Review & Summary of: Initial Research into the Effects of Woody Vegetation on Levees Volumes I-IV

**By US Army Corps of Engineers, Engineer Research & Development Center
as reported by Corcoran et al. (2011)**

Donald H. Gray & F. Douglas Shields, Jr.
(for the California Levee Vegetation Research Program (CLVRP) Science Team)
December 05, 2011

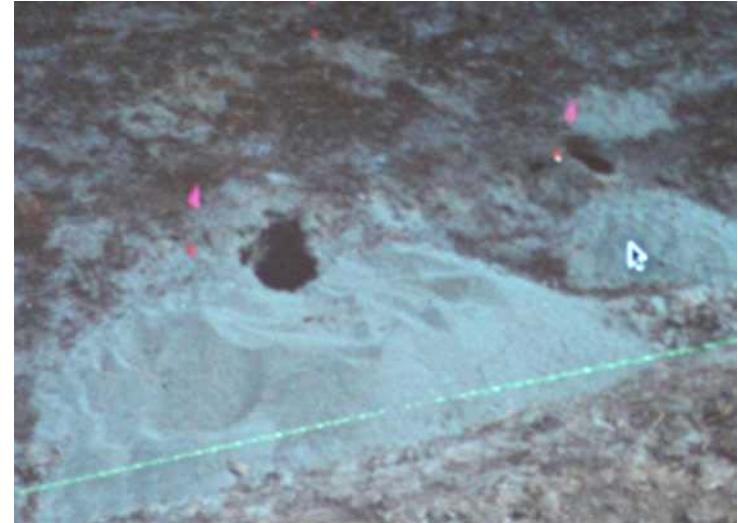
Reviewer Note: No examination of woody vegetation/burrowing animal interactions. See graphic next slide.

Recent studies show that animal burrows are a comparable if not greater cause of seepage erosion and hazard to levees than woody vegetation. See ERDC literature review.

Figure 24b. Cross section G-G' used for the geotechnical evaluation (Golder Associates 2009). Levee fill (dark brown) identified in the bottom profile corresponds to new levee to be added as part of the planned improvements. Only current levee conditions were modeled by FRDC.

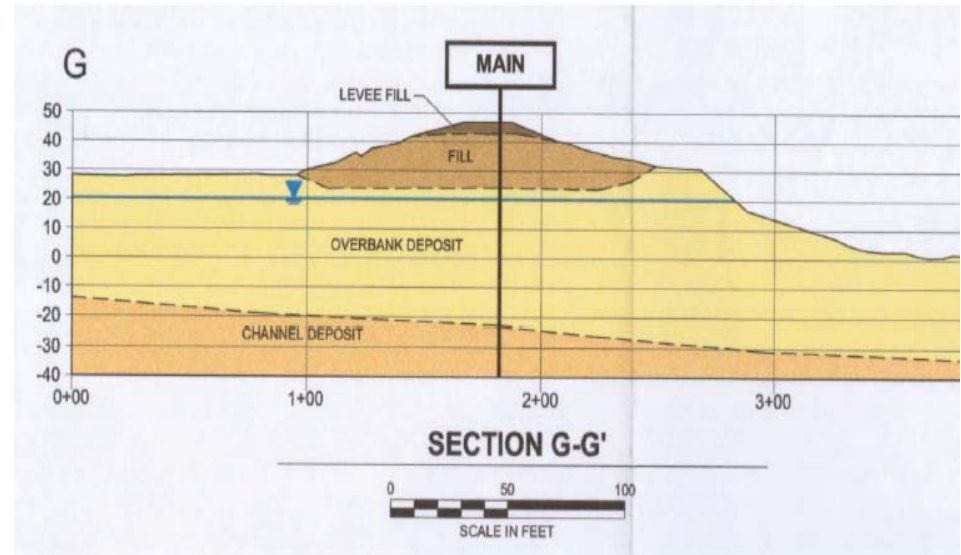
- Geological and geotechnical information compiled from existing reports for all sites.
- This information was used to develop representative cross sections for numerical models.

(Non-Invasive Techniques - Table 36)

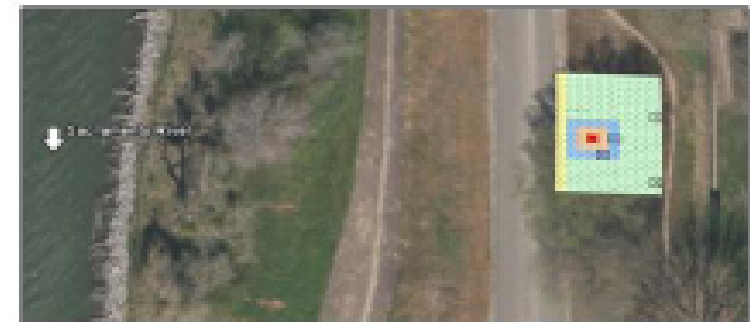
- Ground-penetrating radar tested at 5 sites.
Depth for root zone found at 3 of 5 sites.
- Electrical resistivity imaging tested at 7 sites.
Useful root zone dimensions determined at 4 of 7 sites.
- Electromagnetic induction tested at 5 sites.
Effective at 1 of 5 sites.

- Non - Invasive Techniques
 - Not validated or calibrated using invasive techniques.
 - Effectiveness varied widely with soil texture and soil moisture.
 - Results often contradictory and inconsistent.
 - Root zones sometimes detected, but not individual roots.

Figure 222a. Hydraulic conductivity calculated from in situ permeameter tests at a depth of 3.0 ft, Sacramento, CA.

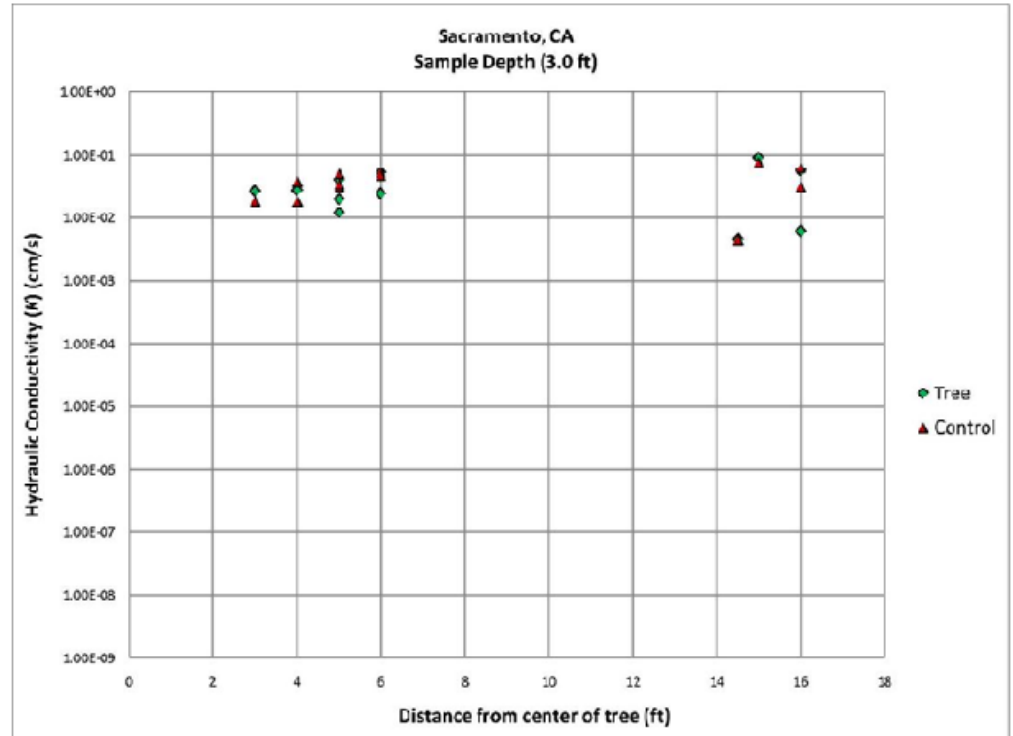
Reviewer Note:

Statistics (areas w/ trees vs. w/out trees) showed no evidence that tree roots influence the average hydraulic conductivity of a soil layer.

(Pg iii) "Only one test showed evidence of an existing macropore associated with a tree site."

Figure 251. Comparison of ERDC and Abernethy and Rutherford (2001) pullout stress vs. root diameter tests.

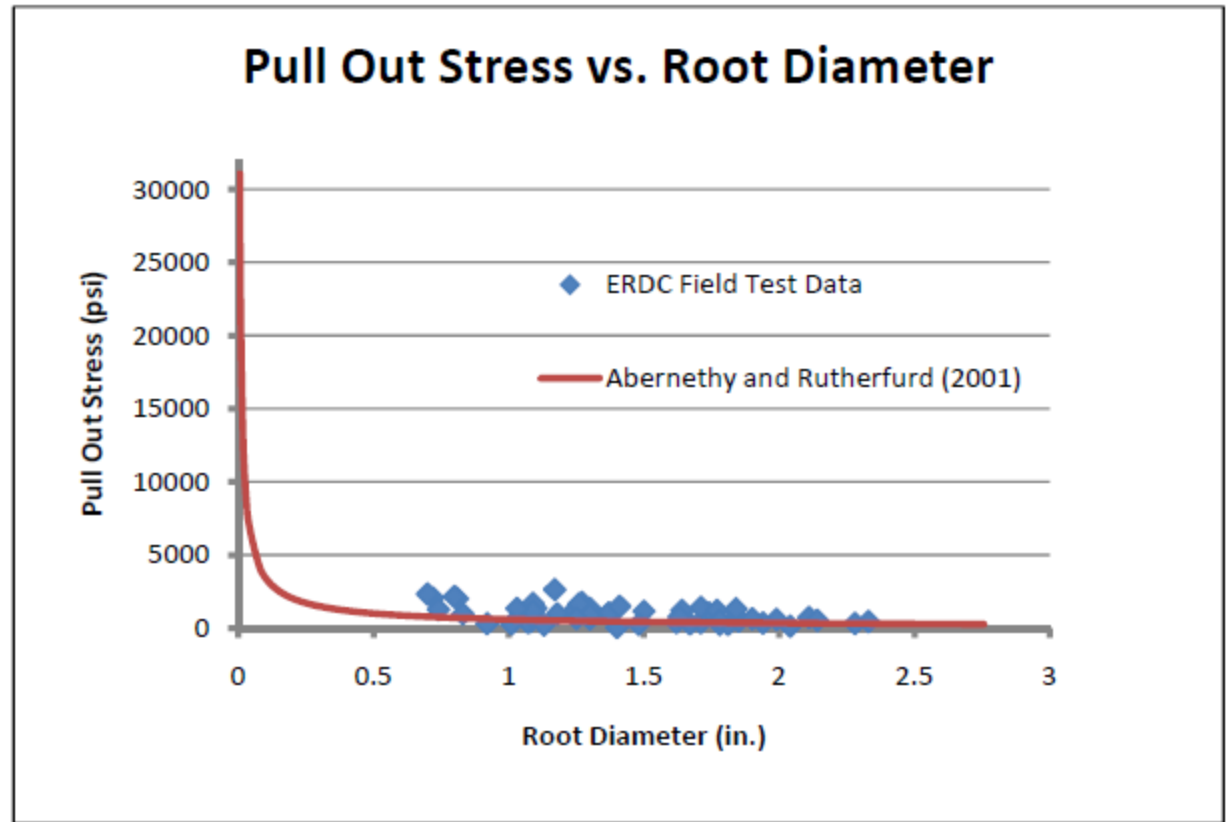
- Tested roots in narrow range of larger diameters 0.7 in to 2.5 in. No effect due to species, but location and diameter were important.
- Work by others shows small roots (< 20 mm diam) have large contribution to soil strength at least at shallow depth.
- Root pullout strength (force required to pull root out of soil), not tensile strength (force required to break a root), was used in numerical slope stability analysis.

Reviewer Note: Use of root pullout strength reasonable because failure tended to occur by slip or pullout.

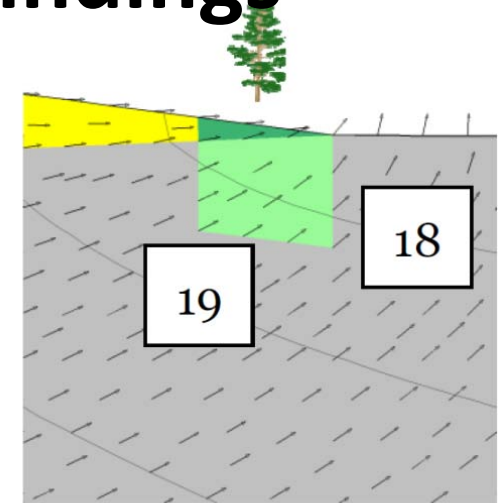
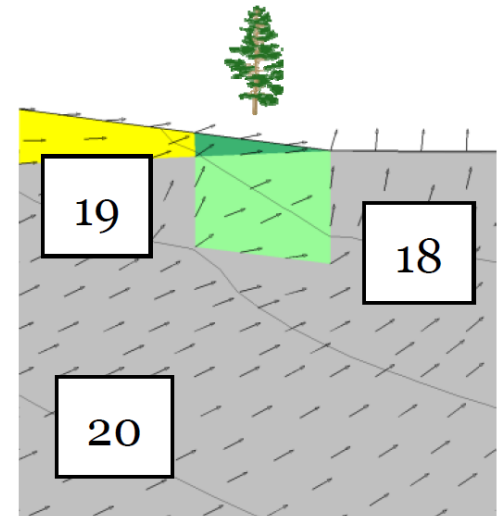
- Sensitivity analysis
- The volume around a root zone was assigned various values of hydraulic conductivity (varied across 4 orders of magnitude) with conditions within the zone assumed uniform.
- Root zones generally affected the flow field within their immediate vicinity, but have virtually no influence on the overall flow field.
- The most likely impact on the flow path or critical gradient occurred when the tree was located at the toe of the levee, but this impact depended on the degree to which the tree altered hydraulic conductivity of the soil.
- Changes in hydraulic conductivity on the riverside do not appear to affect the landside flow conditions.

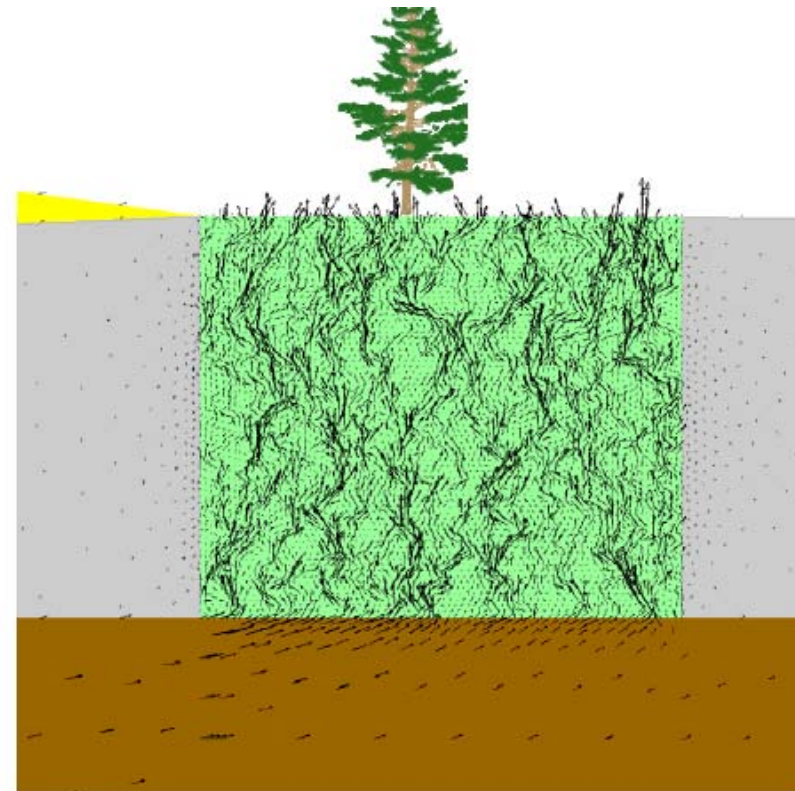
- Representation of vegetation influence as randomly distributed hydraulic conductivity within the block-- “macropore heterogeneity”.
- Resulting seepage velocity vectors show that a random heterogeneous zone can have flow paths that support large flow velocities.
- (Pg. iv) “However, research does not exist on whether high velocities result in the initiation of internal erosion.”

Vectors in root zone larger than for surrounding soils (Pg. 137-138).

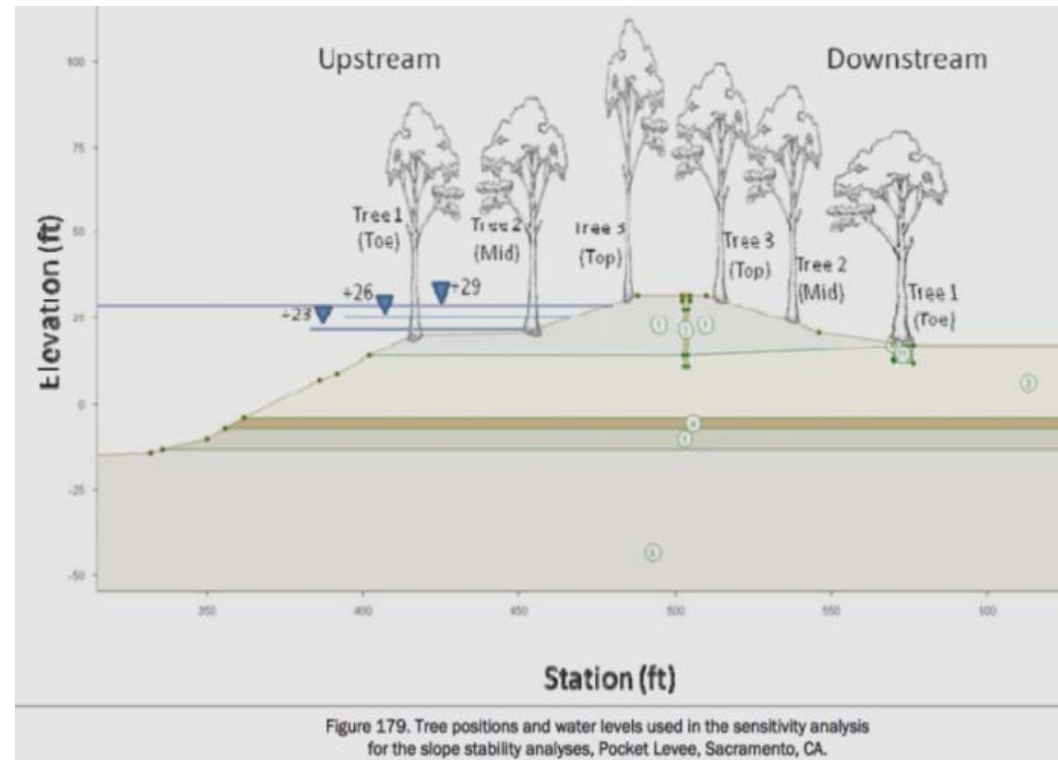
(Pg. V) “In general, this study observed that trees on the upper part of the slope decreased the factor of safety because they add weight. Trees near the toe increased the factor of safety because of the reinforcing effects of the roots and the increased counterweight effect of the tree to slope movement. Trees at midslope had lesser effect on the factor of safety because they acted as a load, but not a counterweight, and the roots are too shallow to reach the failure zone within the midslope region”.

Reviewer Note: Similar findings reported by Norris and Greenwood (2006) and by Danjon and others prior to this study.

Figure 175. Three failure criteria used for calculating the factor of safety on the landside at the Pocket Levee, Sacramento, CA.

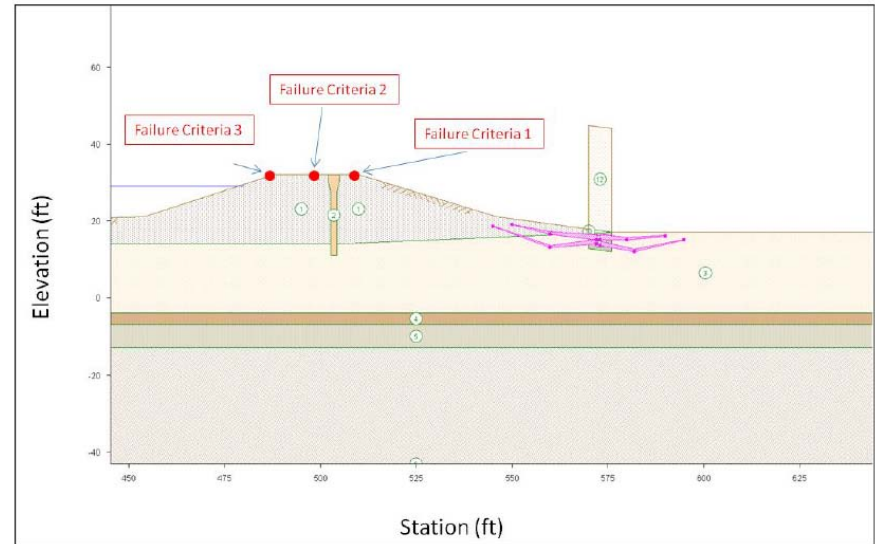
Reviewer note: Probably reasonable approach for the problem at hand, but slope failures in sandy soils tend to be shallow, planar failures and root reinforcement will likely have greater positive impacts on shallow failure zones (Shields and Gray 1992).
